METROPOLITAN GOVERNMENT OF NASHVILLE AND DAVIDSON COUNTY

Metropolitan Historic Zoning Commission
Sunnyside in Sevier Park
3000 Granny White Pike
Nashville, Tennessee 37204
Telephone: (615) 862-7970
Fax: (615) 862-7974

STAFF RECOMMENDATION
409 Broadway
March 16, 2016

Application: Alterations

Figure 1. 409 Broadway

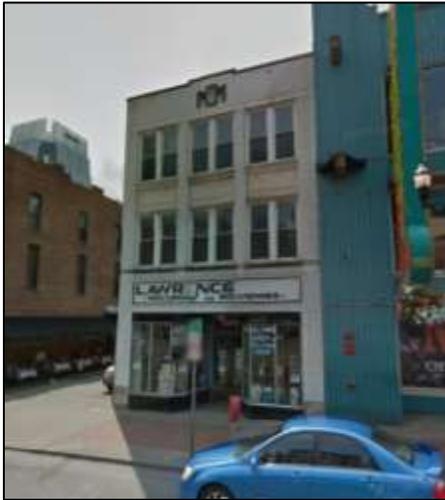
Background: 409 Broadway is a three-story commercial building. The National Register nomination dates the building to 1910. According to the city directories, it was a grocery for its first few years and was then Phillips & Quarles Hardware Store at least from 1931 to 1951. The Lawrence Brothers Shoe and Western Wear Store started in 1954 and the family switched to the Lawrence Brothers Record Shop in 1964. The name changed to Lawrence Record Shop in 1994 when Jack Lawrence, Sr died and the business was run by his widow Ida Lawrence and one of her sons.

Figure 2. Historic storefront

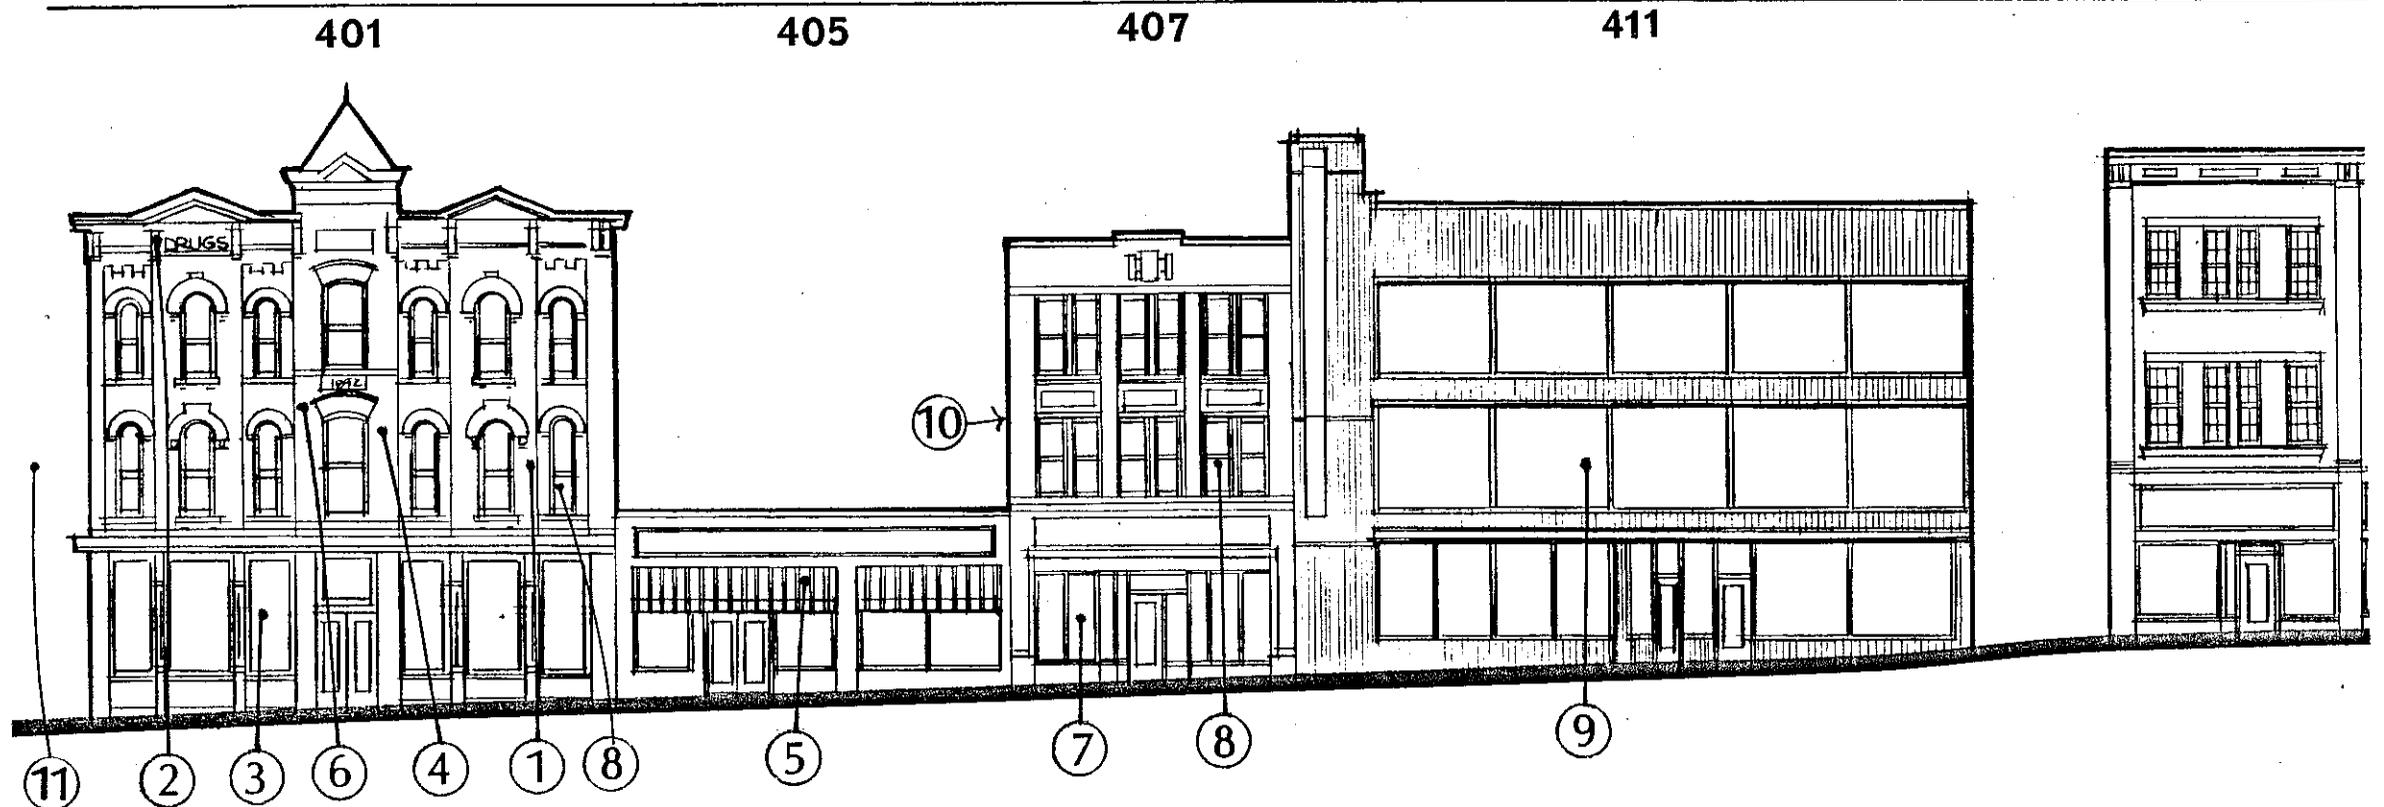
Storefront, Display Windows, Bulkheads: The current storefront includes structural glass and storefront windows. In the 1930s, structural glass such as Carrerra and Vitrolite, became popular as a way to update earlier storefronts and across the country is commonly considered a historic character defining feature. This particular glass may have been installed a little later. The family dramatically changed their business in 1964 from a Western Wear store to a record shop which may have been the time of the update. The earliest photograph the department has on file is from the 1970s and shows the black glass. Although it may not be as early as 1930, it is still considered a historic feature of the building.

A Market and Design Study for the Broadway National Register Historic District, commissioned in 1982, called the building an “architecturally significant structure” and made the following recommendations:

- Repair existing storefront or install compatible contemporary storefront;
- Restore upper façade windows;
- Maintain or restore painted sign at side of building.

Since 1982 however, the storefront has passed fifty years of age and has become an important historic element of this building.

1 BROADWAY ELEVATION
3/16" = 1'

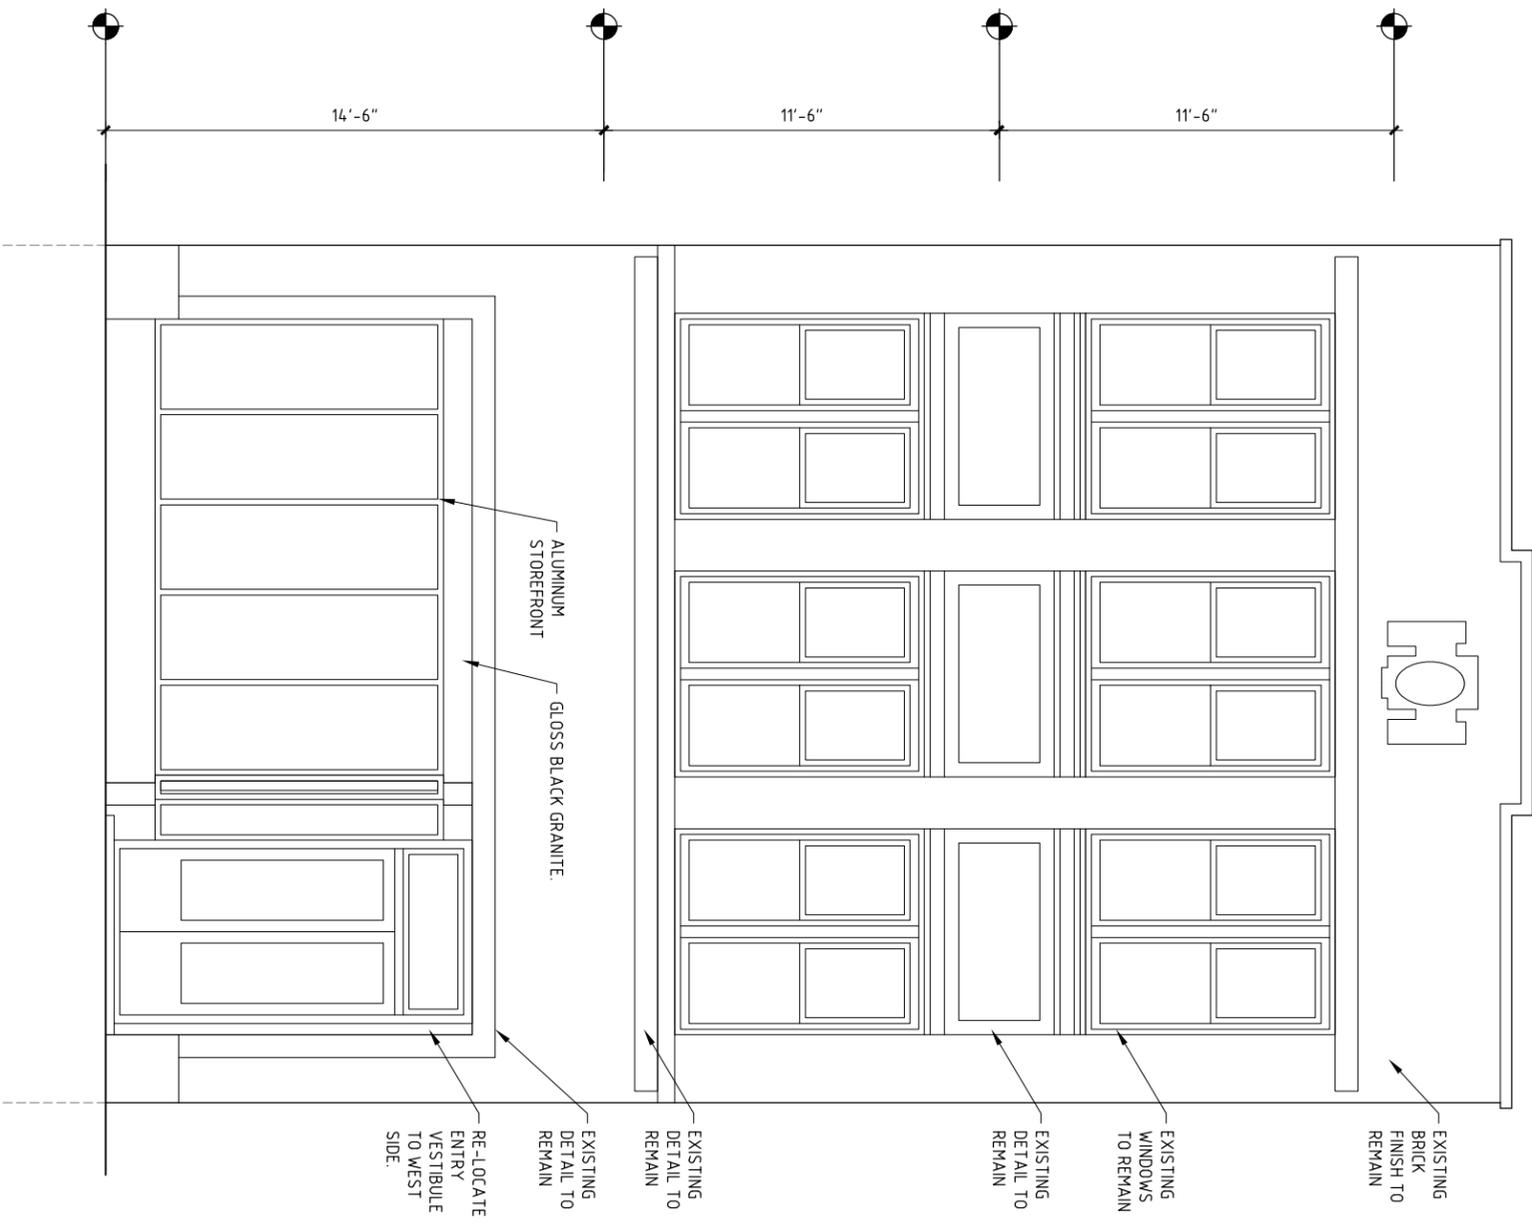
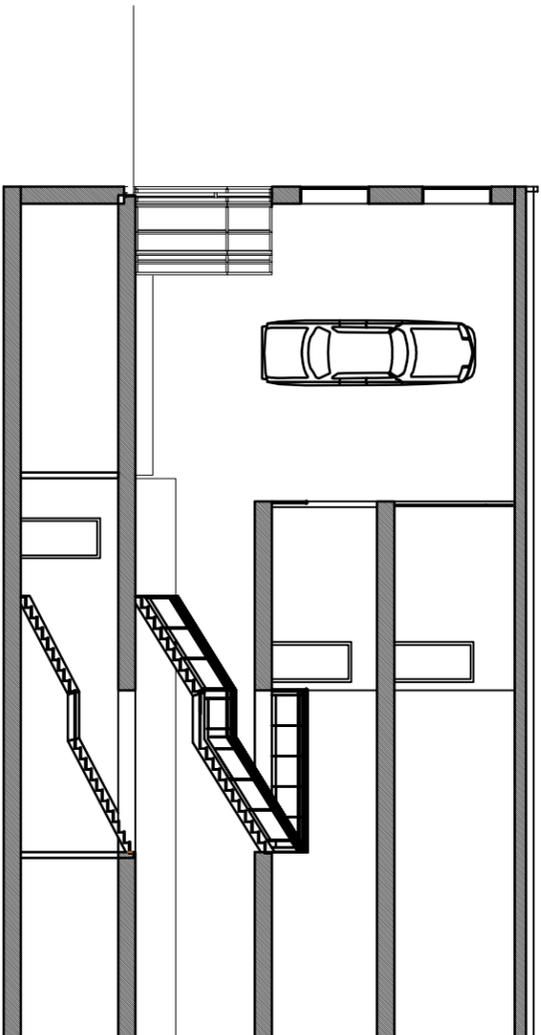
The applicant proposes to alter the storefront at 409 Broadway by relocating the central entrance to one side and reconstructing the storefront in order to construct a two-story atrium in the interior.

The applicants are requesting the reconstruction of the storefront because of the desire to construct an atrium inside. Under section II. *Rehabilitation, general principles*, the design guidelines state that “interior changes that affect the exterior appearance of upper facades including changing original floor levels should be avoided.” Although this section states it is for upper level windows, staff believes this is only because it was not contemplated that interior alterations, such as changing floor levels, would negatively affect the storefronts. This is in keeping with the Secretary of Interior Standards, on which the design guidelines are required to be based on according to state law. Secretary of Interior Standard #1 for Rehabilitation (design guidelines section I.B) states that “A property shall be used for its historic purpose or be placed in a new use that requires minimal changes to the defining characteristics of the building and its site and environment.” Staff finds that the interior changes are the only reason for the reconstruction of the historic storefront and therefore the proposal does not meet section II.A. and E of the design guidelines.

Doors and Entryways: The applicant proposes relocating the entryway to the right side of the storefront. The existing configuration is a historic element of this building. The design guidelines require to the configuration of historic doors and entrances be retained. In addition, the need for the relocation is due to interior alterations as described previously, which does not meet the Secretary of Interior’s Standards. Staff finds that the project does not meet section II.A and B

Recommendation: Staff recommends disapproval of the application, finding that the proposed alterations to the storefront do not meet the principles of the Secretary of Interior’s Standards (section I.B), or sections II. A, B, C, and E of the design guidelines for the Broadway Historic Preservation Zoning Overlay.
